# Access Compliance Report

## Public Rights-of-Way

### (Curb Ramps)

Intersection ID: N/A	Main Street: E 8TH ST	Cross Street: N BREVARD ST	Location: E
ADA ID: FAF3244416FC	Ramp Type: Perp	Initial Pass/Fail: Fail	Overall Compliance: No
Severity Score: 12.5			
Codes/Mitigation Info/Possible Solution		Field Measurements/Component Compliance

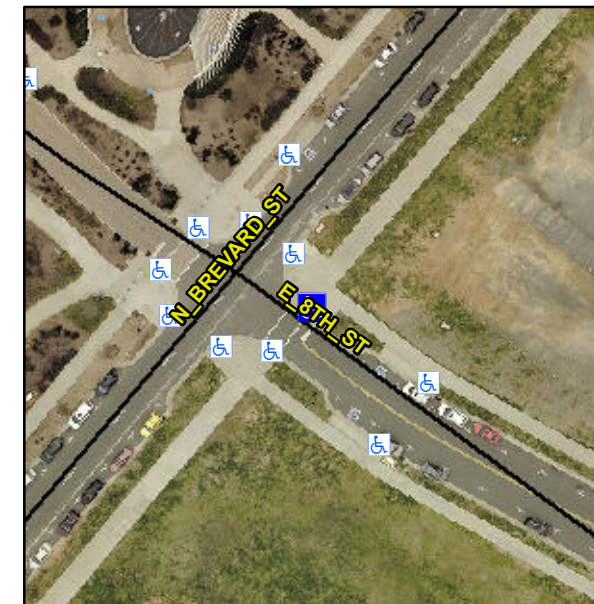
**Not Found, R304.5.3**

Compliance	Description	Data	Compliance	Description	Data
N/A	Ramp Length (in)	85.5	Yes	Ramp Slope (%)	6.8
Yes	Ramp Width (in)	48.0	No	Ramp XSlope (%)	5.4
N/A	Flare Type LT	N/A	N/A	Flare Type RT	N/A
N/A	Flare Slope LT (%)	N/A	N/A	Flare Slope RT (%)	N/A
N/A	Flare Traversable LT?	No	N/A	Flare Traversable RT?	No
N/A	Landing Length (in)	N/A	N/A	DWS Provided?	N/A
N/A	Landing Width (in)	N/A	N/A	DWS Contrast?	N/A
N/A	Landing Slope (%)	N/A	N/A	DWS Length (in)	N/A
N/A	Landing X Slope (%)	N/A	N/A	DWS Full Width?	N/A
N/A	Landing Curb? (Y/N)	N/A	N/A	DWS Offset (in)	N/A
N/A	Shared Landing?	N/A			
N/A	Gutter Ponding?	N/A	N/A	Gutter Slope (%)	N/A
N/A	Gutter Lip Ht (in)	N/A	N/A	Gutter X Slope (%)	N/A
N/A	Painted X Walk1?	Yes	N/A	Painted X Walk2?	N/A
	X Walk 1 Direction	To SW		X Walk 2 Direction	N/A
N/A	X Walk 1 Width (in)	112.0	N/A	X Walk 2 Width (in)	N/A
	X Walk 1 Slope (%)	3.0		X Walk 2 Slope (%)	N/A
	X Walk 1 X Slope (%)	3.0		X Walk 2 X Slope (%)	N/A

**Remove & Replace Entire Ramp.**
